The City of San Diego

Staff Report

SUBJECT: Consideration of Alternate Methods and Materials Application PRJ-1165197 for 3450 El Cajon Boulevard – (PRJ-1077714)

CONSTRUCTION TOLERANCES
CODE MODIFICATION
EQUIVALENT FACILITATION
ALTERNATE MEANS AND METHODS
CORRIDOR WIDTH
FEATURES FOR PERSONS WITH DISABILITIES
2019 CALIFORNIA BUILDING CODE

w obrarchitecture.com

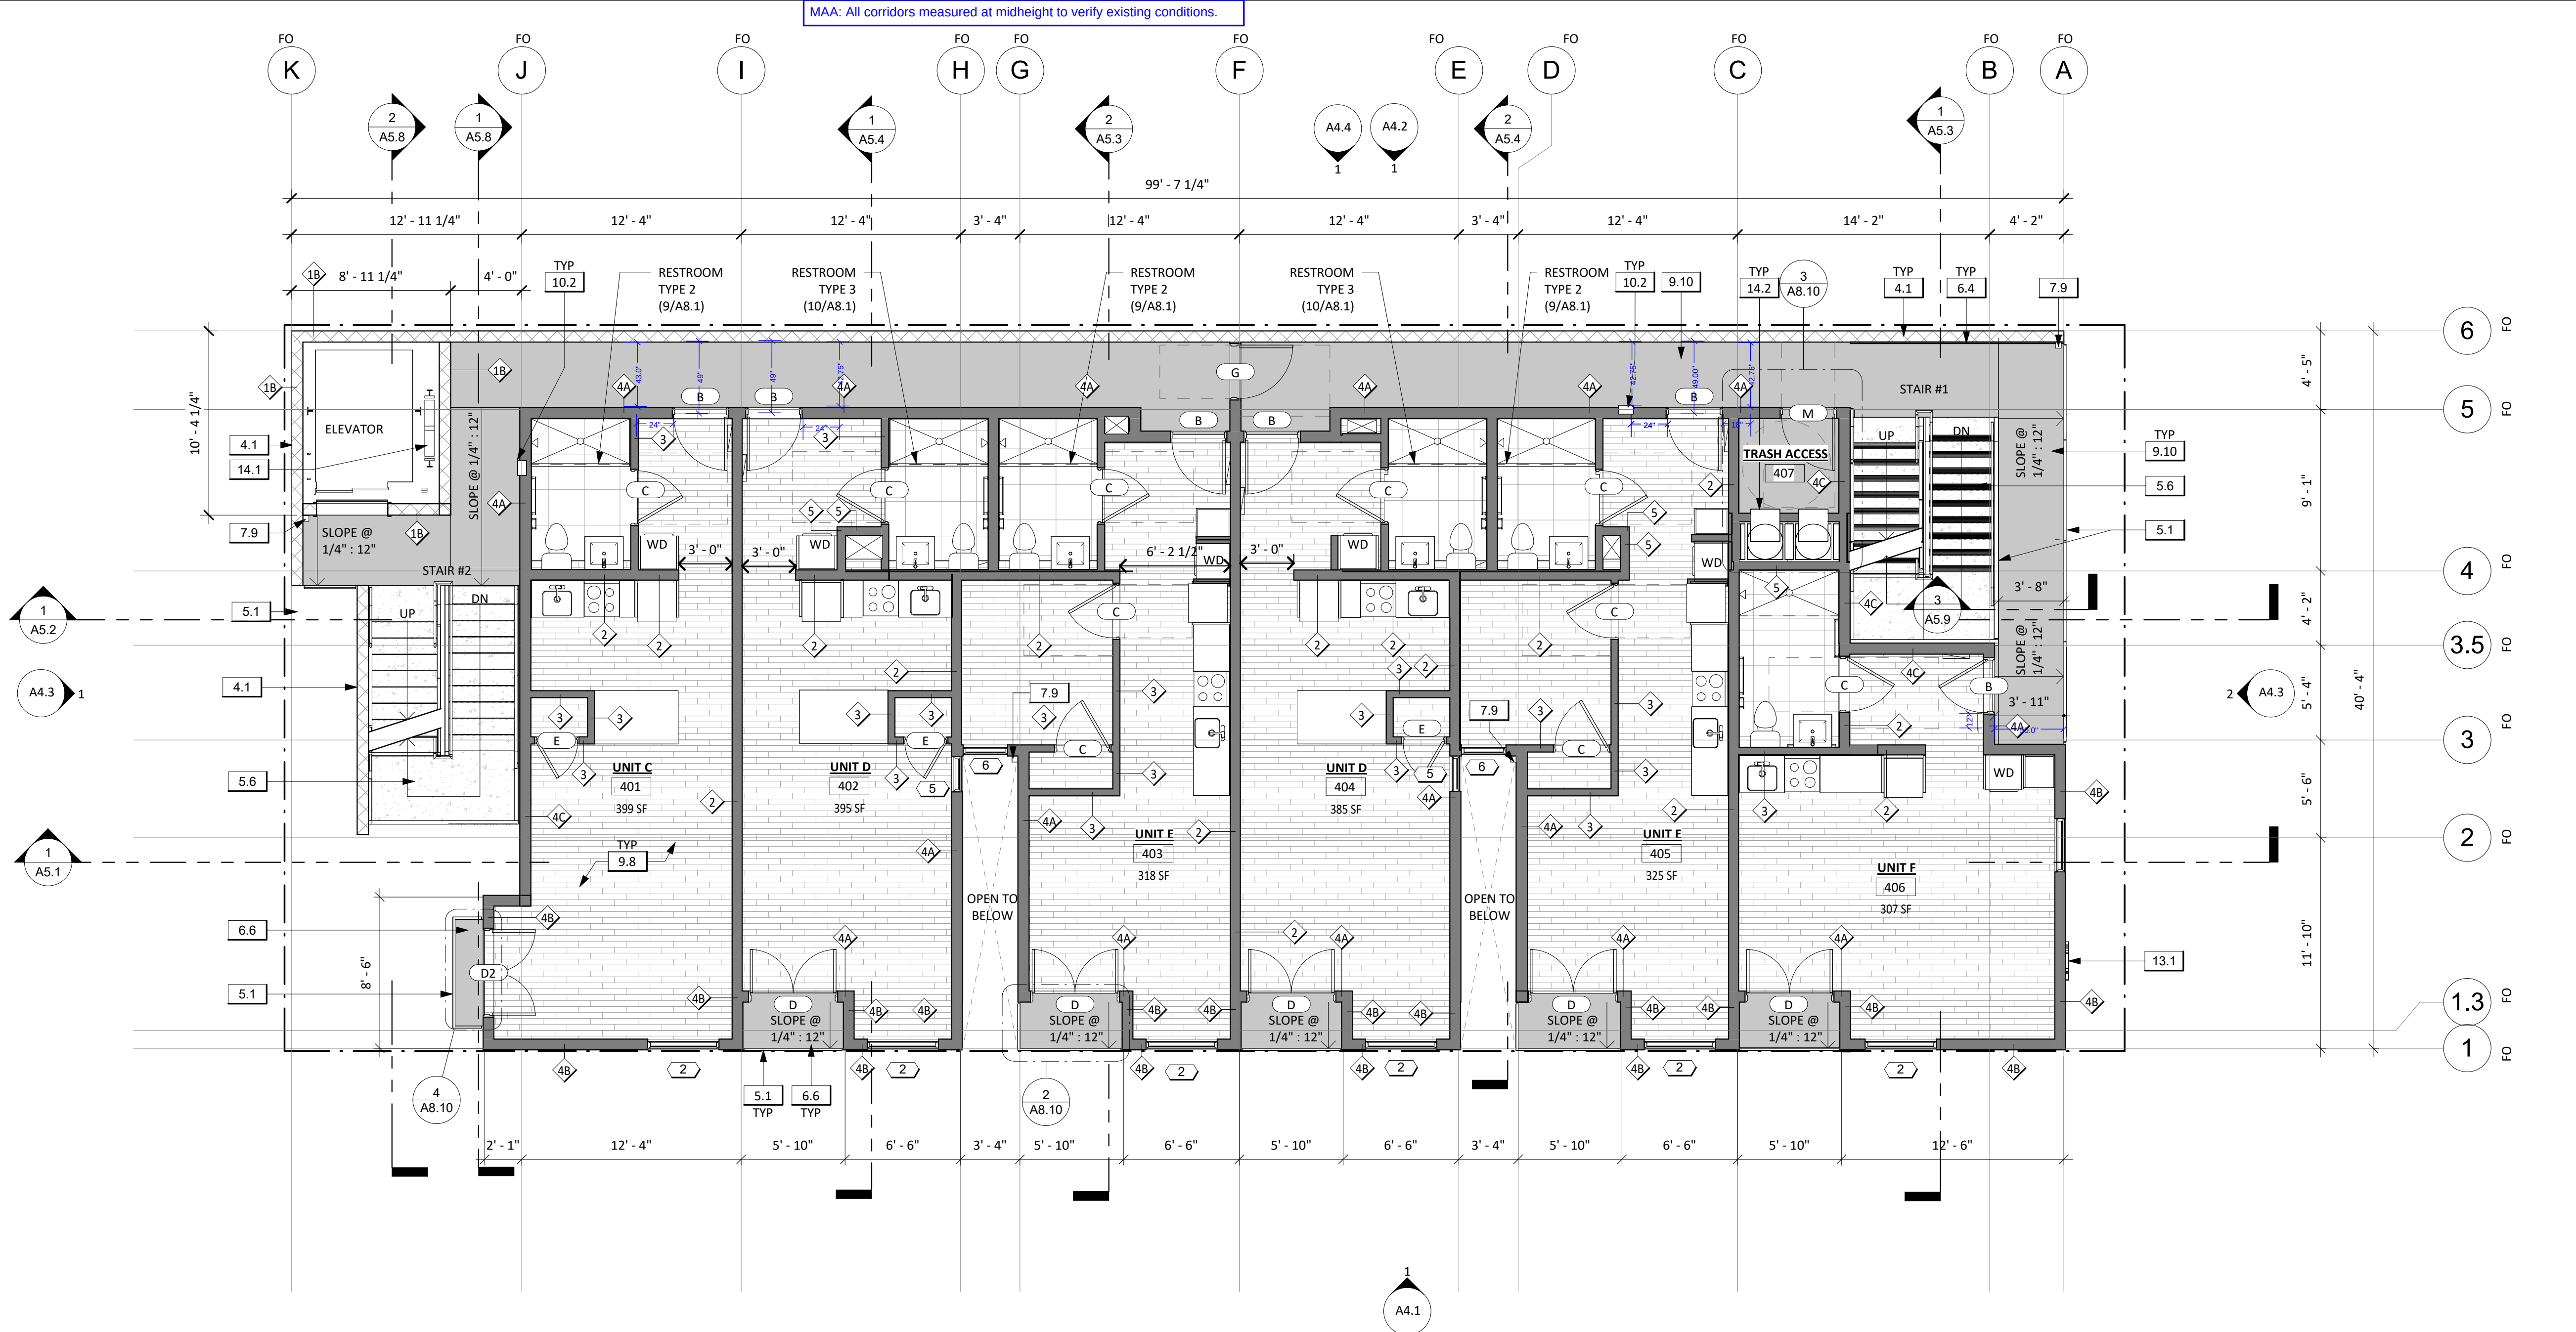
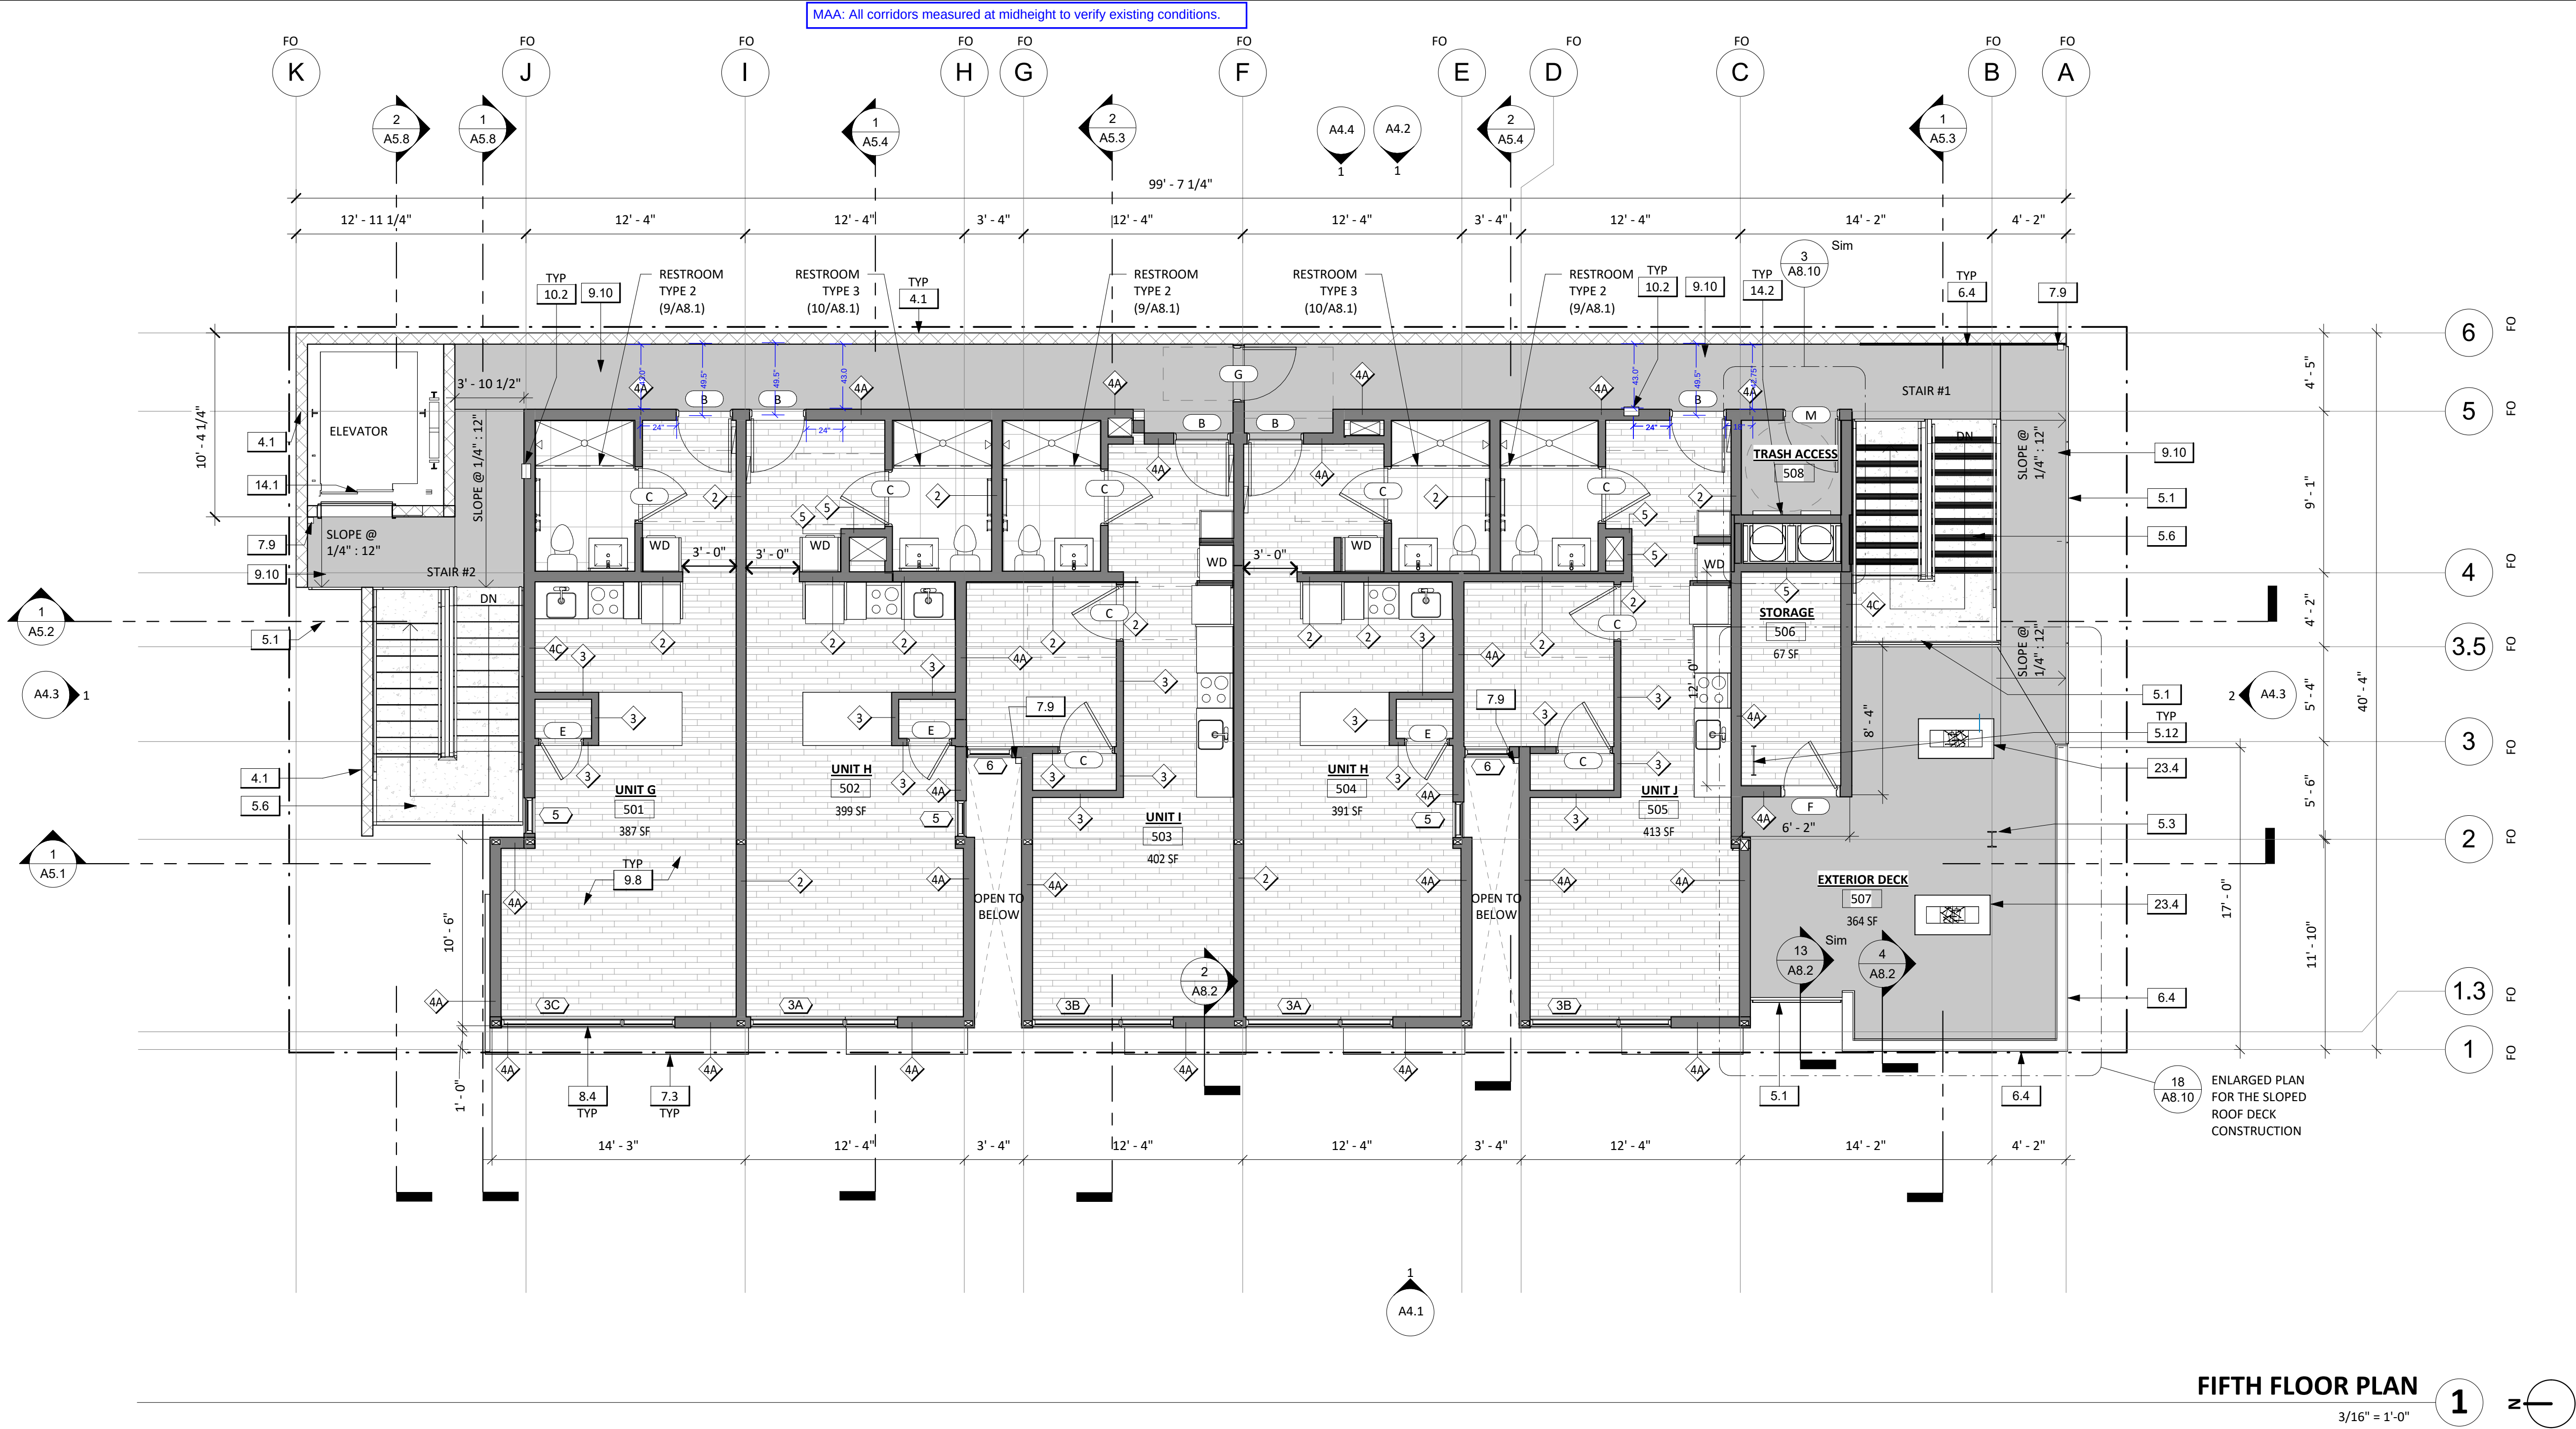
See table for Front Approach analysis on the following page. Measurements in the table for as-built corridor widths at the locations for door maneuvering clearances are taken from and shown on the attached floor plans at the end of this report.

See table for Side Approach analysis on the following page. Measurements in the table for as-built corridor widths at the locations for door maneuvering clearances are taken from and shown on the attached floor plans at the end of this report.

1. Remove door closers and replace the standard door hinges with fire-rated self-closing hinges at the affected 16 doors i.e. 4 trash rooms doors (Rooms 207, 307, 407 and 508) and 12 unit entrance doors (Unit Nos. 201, 202, 205, 301, 302, 305, 401, 402, 405, 501, 502, and 505).
